SAFEWAZE PERSONNEL WINCH BRACKET UPDATE INSTRUCTIONS

Safewaze has redesigned the device bracket of the Personnel Winch to accommodate Xtirpa systems.

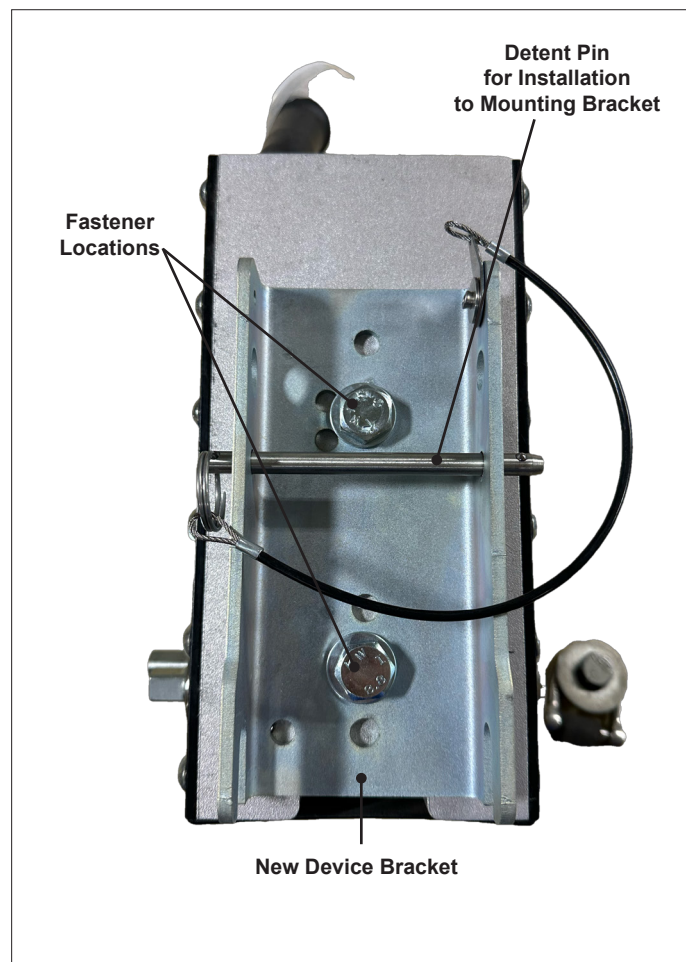
In order to retrofit an existing device in the field, please follow these instructions:

1. Order the new device bracket (024-11050, bracket and fasteners included).
2. Remove current fasteners and bracket from Personnel Winch. This may require some force if Loctite is present on original bolts.
3. Align the new bracket onto the device as shown.
4. Reinsert new fasteners as shown.
5. Apply red Loctite to bolts.
6. Torque bolts to 80 Nm. Be careful not to over-torque.

024-11050 Fasteners:
(2) M12 x 1.75mm Bolts
(2) Flat Washers
